Application No.: 10/088,767

Title: DIRECT CURRENT MOTOR CONTROL CIRCUIT

**PETITION UNDER 37 CFR 1.181(a) TO WITHDRAW  
THE HOLDING OF ABANDONMENT**

**AMENDMENT AND RESPONSE TO OFFICE ACTION**

Fig 1

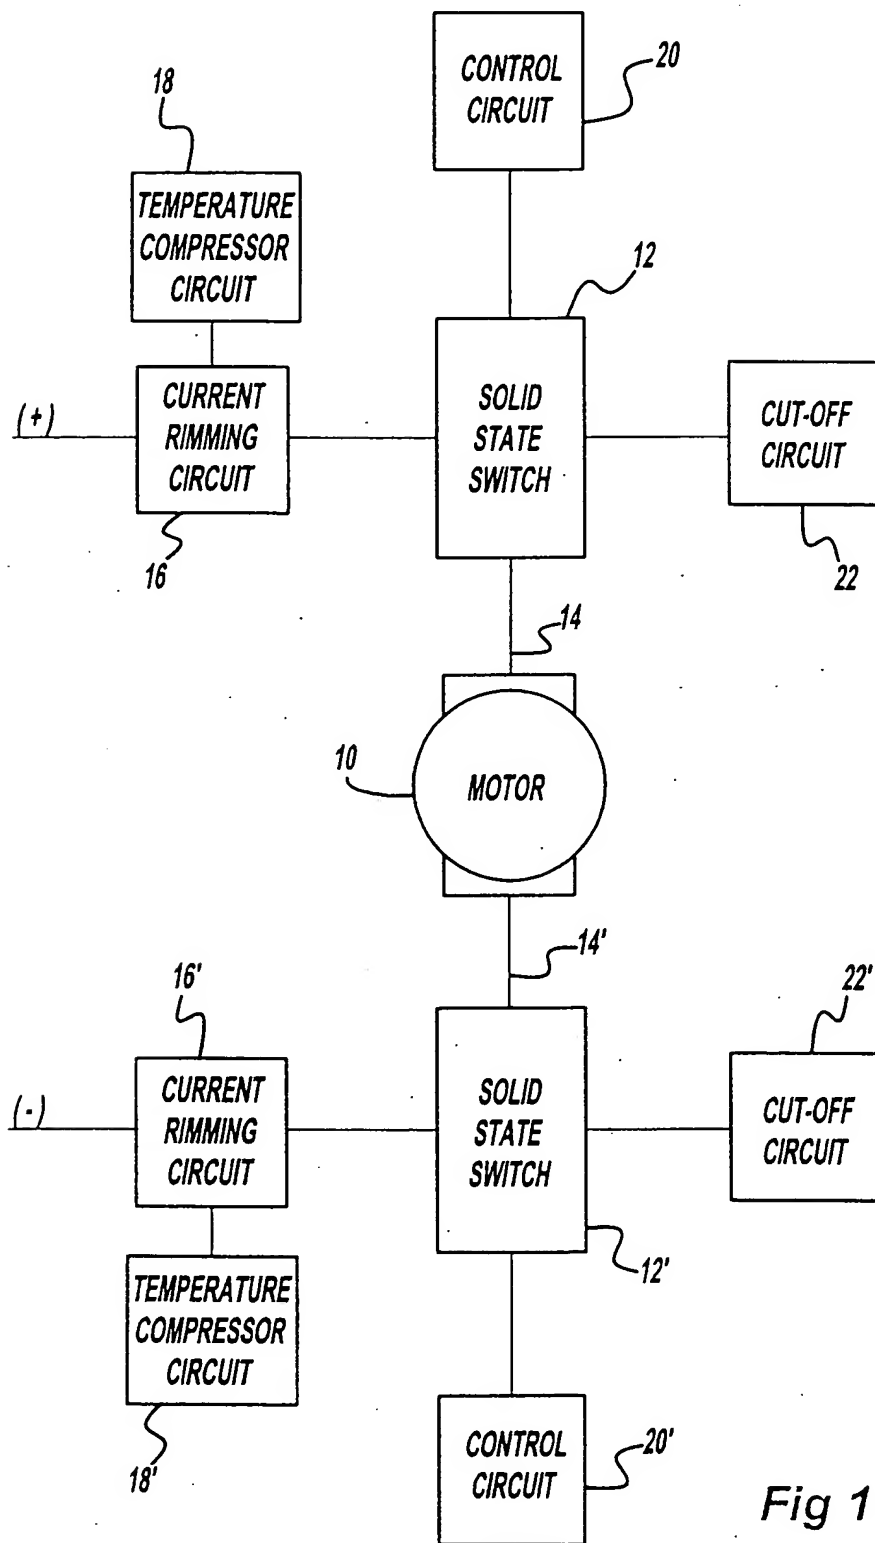
1. The drawings are objected to because fig 1 needs to be labeled descriptively. A proposed drawing correction or corrected drawings are required in reply to the Office action to avoid abandonment of the application. The objection to the drawings will not be held in abeyance.
2. Applicant is reminded of the proper language and format for an abstract of the disclosure.

The attached drawing includes changes to Fig. 1. As required by Examiner, Applicant has amended the drawings to include descriptive details. These amendments add no new matter and support for the amendments can be found throughout the detailed description section of the specification.
